**INDIAN INSTITUTE OF SCIENCE EDUCATION AND  
RESEARCH THIRUVANANTHAPURAM [IISERTVM]**

**CORRIGENDUM**

**Sub: Supply Installation and commissioning of 9 fume hoods, ducting system and three flammable storage cabinet in Lab 4203 and Lab 3211 in the chemical science block and Lab 2111 in Physical science block at IISER campus Vithura**

**Ref: Tender Enquiry No. 2021\_IISRT\_624004\_1**

Lab 2111

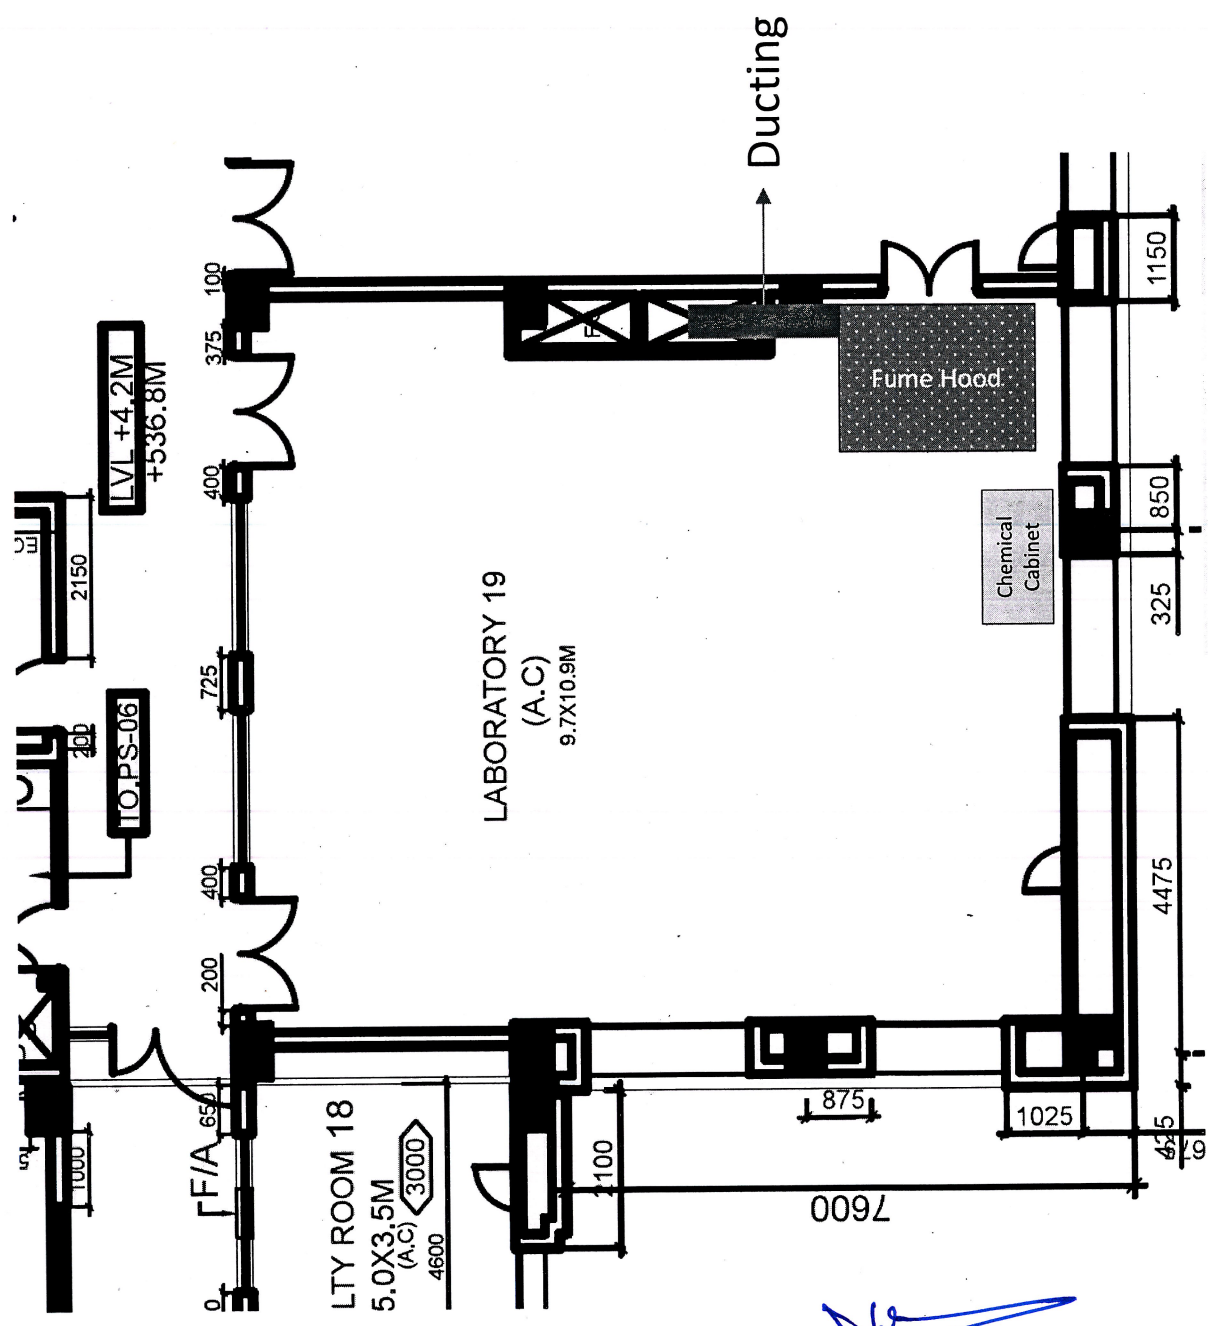
| Sl No | Clause   | Specification   |
|-------|--|---|
|       | General- the tentative layout of each lab indicating the location of each fume hood. | As per Enclosed layout's  |

| Scale  | Title                                   | Project No.  |
|--------|---|--------------|
| N.T.S. | PROPOSED LAYOUT OF LAB FOR DR. SOUMEN I | LAB No. 4203 |

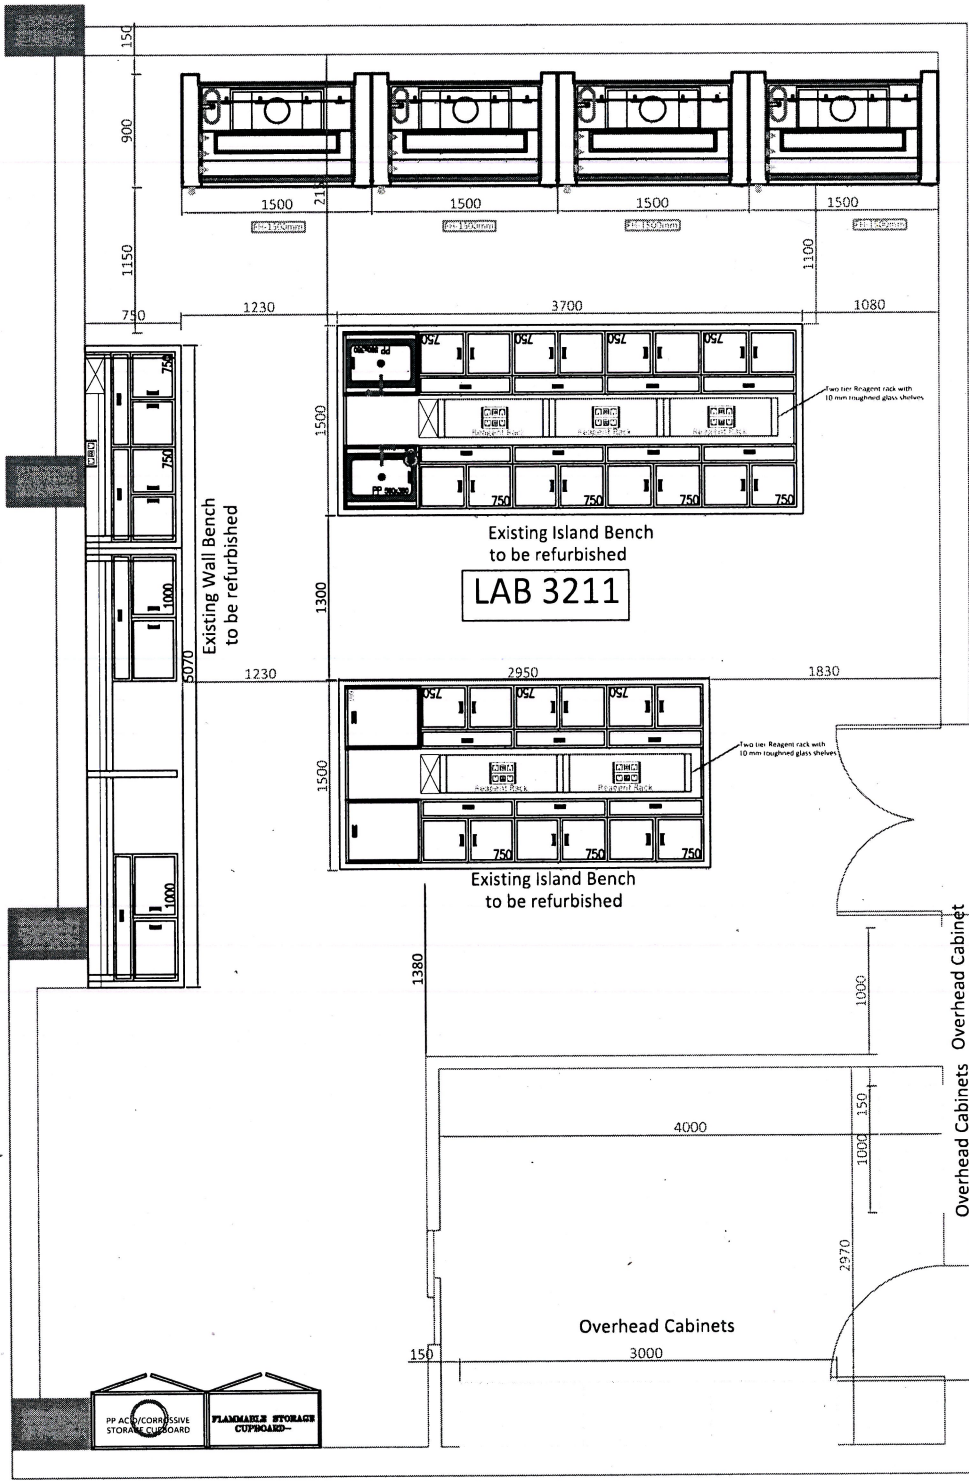
- NOTE**
1. TWO SIDE TABLE 1+1 UNITS TO BE DISCARDEC
  2. SIDE TABLE 4 UNITS TO BE SHIFTED TO OFFICE
  3. SIDE TABLE 2 UNITS TO BE DISCARDED.
